Technical Review of JKR's "Handbook on Seismic Design Guidelines for Concrete Buildings in Malaysia"

By: *Engr. Dr. Jeffrey Chiang, M.I.E.M., P. Eng and Engr. M. C. Hee, F.I.E.M., P. Eng*

Figure A1.1: Macrozonation Map for 500 years return period at $T=0.2$ sec.

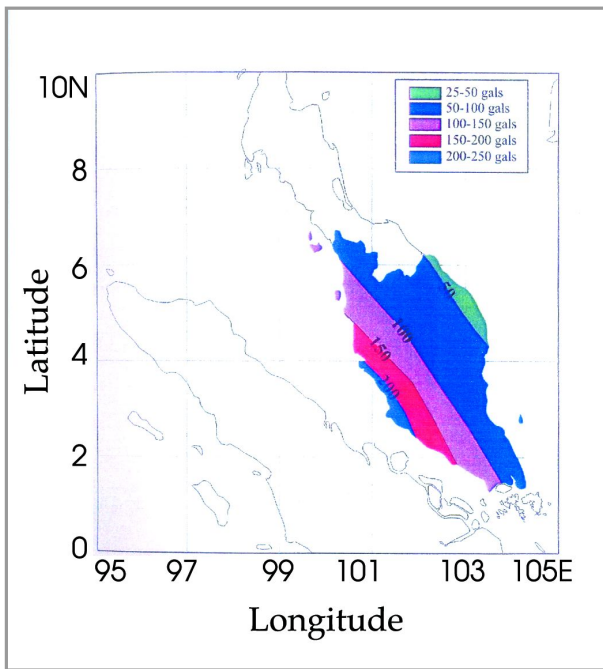
For the uninitiated, the term 'gals' refers to the acceleration experienced in a ground motion due to the seismic effect from a certain distance away from the epicenter. $1000 \text{ gals} = 1 \text{ g} = 9.81 \text{ m/s}^2$. Hence, in the macrozonation maps, as shown in the guidelines, values of 200 to 250 gals have been quoted in the extreme cases for Peninsular Malaysia in the west coastal regions, for 500 years return period at natural period of 0.2 sec. This means that the peak ground acceleration or PGA is between 0.2g to 0.25g – which is relatively high. As a comparison, the Penang link bridge was designed to resist a seismic effect of 0.03g , which is

considered moderate by usual practice. A design for 0.2g to 0.25g would be regarded as medium to high risk seismic effect, which is not practical for building structures in Peninsular Malaysia. Refer to Figure A1.1 for the macrozonation map mentioned.

Hence, the quoted PGA values as given in the various macrozonation maps have to be explained and justified before they can be accepted for design practice on a practical basis by local engineers.

Figure A1.11: Macrozonation Map at 10% PE in 50 years on rock site conditions for the Peninsular Malaysia. (TR = 500 year) (Source: CIDB report)

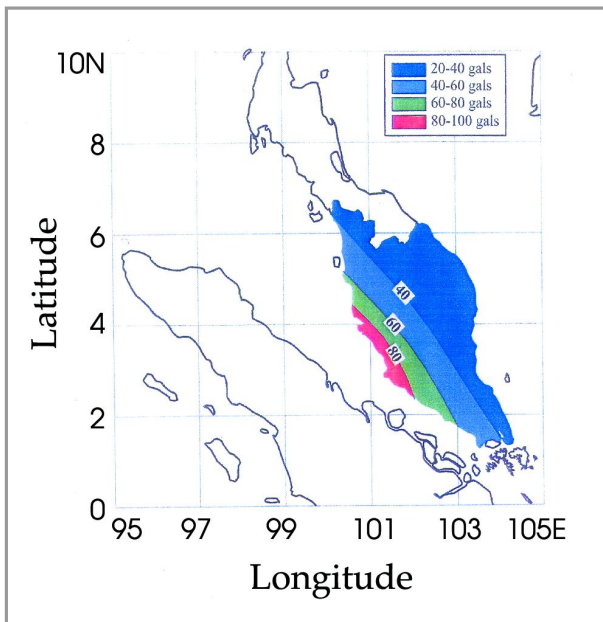
In another macrozonation map of the Peninsular Malaysia for a 10% probabilistic effect (PE) in 50 years on

rock site conditions (refer to Figure A1.11), the worse case scenario is also along the west coast at a quoted range 80 to 100 gals – which is also considered on the high side of between 0.08g to 0.1g. Even the Bakun Dam in Sarawak was said (by a speaker in a recent IEM seminar on Earthquake and Tsunami) to have a seismic design PGA of 0.075g, and mind you, East Malaysia do experiences direct seismic forces unlike Peninsular Malaysia, which at best experiences only far field seismic effect from Sumatra.
